WARRANTY BULLETIN

Campaign no.: 2020-0005

Subject: **Spyder® RT - Abnormal Gaps Around the Rear Cargo Module Access Covers**

No. **2020-3**

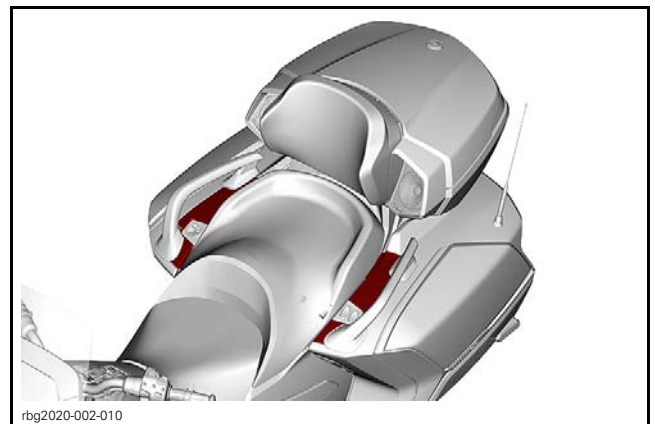
The interference between access covers and frame prevent mounting holes alignment. This situation creates abnormal gaps around both rear cargo module access covers.

Abnormal gaps are present between both rear cargo module access covers and adjacent body parts.

To minimize the gaps, only the access cover rear screw was installed from factory.

The front was intentionally secured with a locking tie instead of a screw.

1. Locking tie

Replace both access covers and install screws instead of the locking ties.

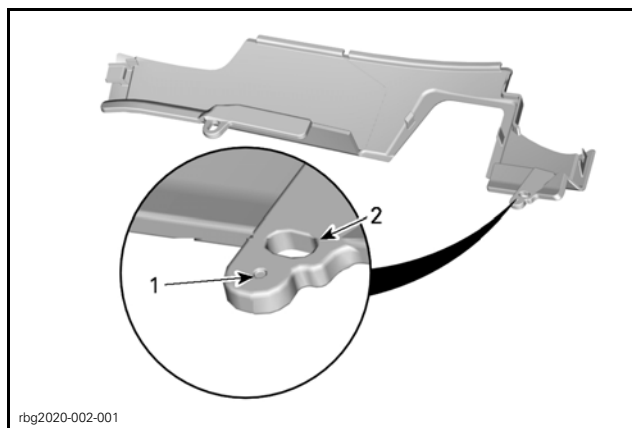
1. Remove the passenger seat.
2. Cut the locking tie securing the front of the access cover.
3. Remove and keep the rear screw.
4. Remove and discard the access cover.
5. Turn the new access cover upside down.
6. Using a 5mm drill bit, drill a hole on the front tab, under the front slotted hole.

1. Molded dot where drill
2. Front slotted hole

7. Position the access cover and loosely install the previously removed screw and a new K50 x 16 Torx screw.
8. Move the access cover to have an equal gap in back and in front.
9. Hold the access cover in this position and tighten screws.

Access cover screws	2.75 N•m ± 0.25 N•m (24 lbf•in ± 2 lbf•in)
---------------------	---
